CITY OF SANTA FE

# Planning and Land Use Department Planning Commission Staff Report

**Case No:** 2023-7752

**Request:** Preliminary Serial Subdivision Plat

**Figure 5: Access Off Beckner Road and Internal Circulation**

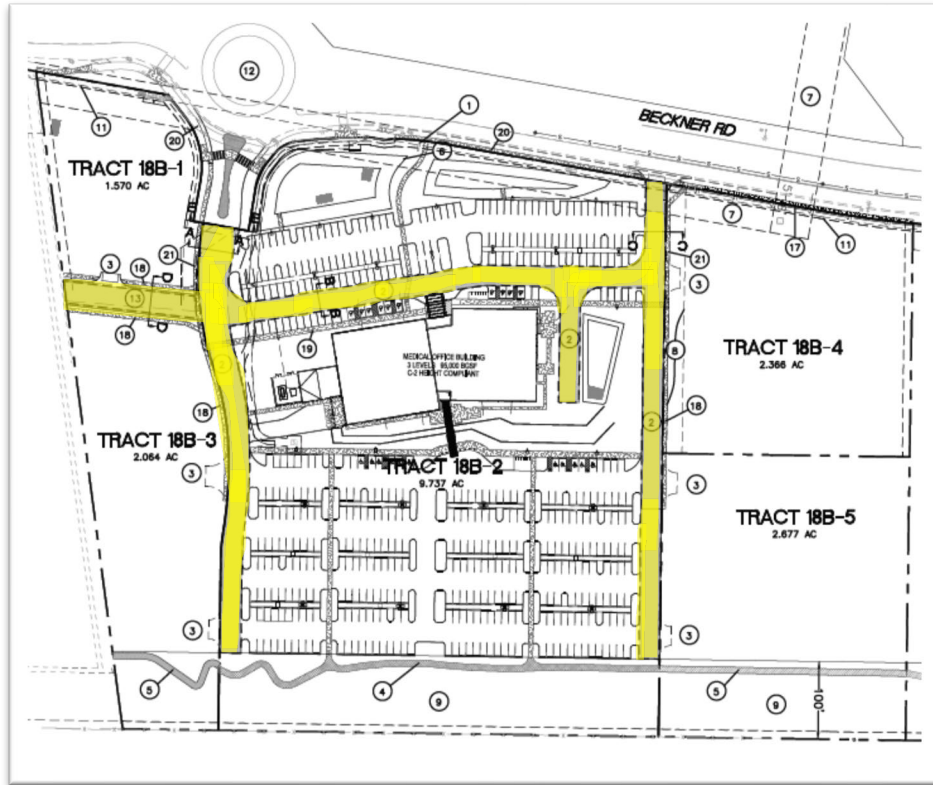
Per the *International Fire Code 2021*, the Fire Marshal requires 10' auto lanes for a total width of 20' driving surface. In the final subdivision plat, which is the next step in the subdivision platting process, the Applicant will dedicate all internal streets and roundabout rights-of-way to the City. The proposed street design includes internal subdivision roads as a "lot access driveways." Although this road typology has no minimum required total right-of-way (ROW) width, the Applicant is proposing 26' wide ROWs (including sidewalks) for them. One exception to this is the 52' ROW for a future road that will run between Tract 18B-1 and 18B-3, connecting this subdivision to the future adjacent subdivision to the southwest. In addition to requiring this wider ROW width for the future road, the City Engineer requires an access and utility easement with a minimum width of 42-feet for the roadway that runs between lots 18B-1 and 18B-2, connecting the future 52' ROW to the existing roundabout at Beckner Road.

**Figure 7: Street Detail**

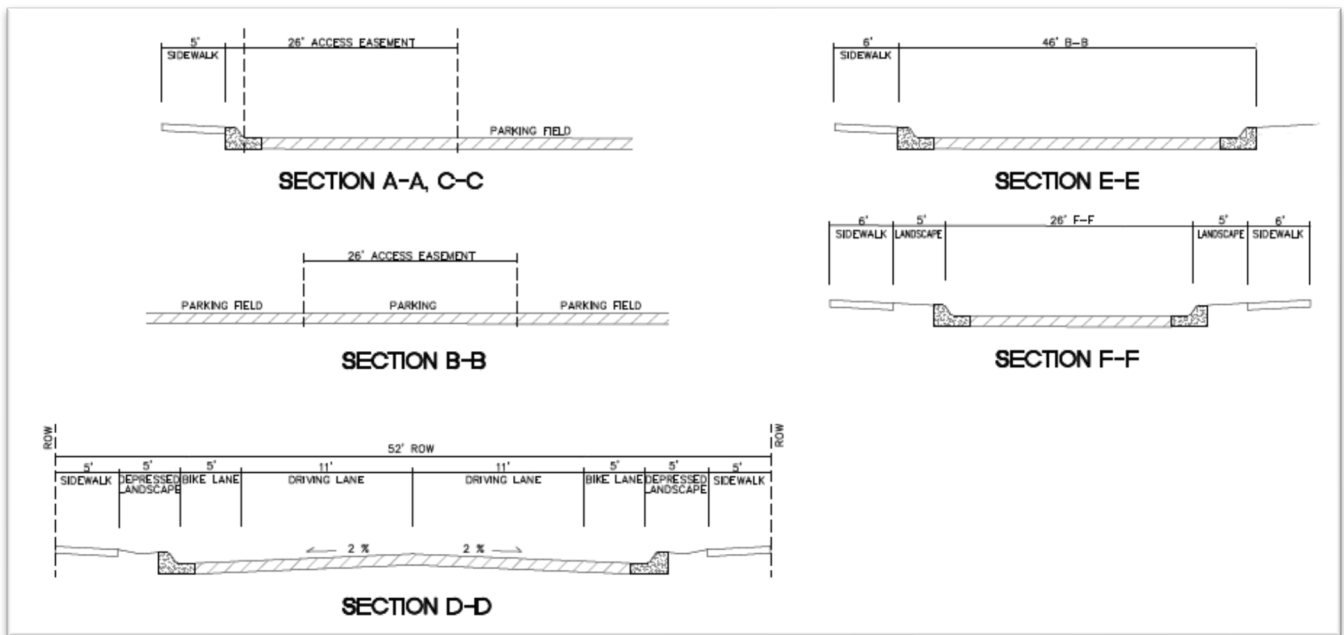
In Table 1, Condition #2, the City Engineer also requires that "Street cross-section D-D" (shown below in Figure 7), as depicted in the Applicant's materials, be revised to reflect the current City design practices of 10' vehicle travel lanes and 6' sidewalks. See Figure 7, below, also from Sheet #3 ("Access Exhibit") of the Applicant's Materials (see Attachment D) for the proposed road cross-sections:
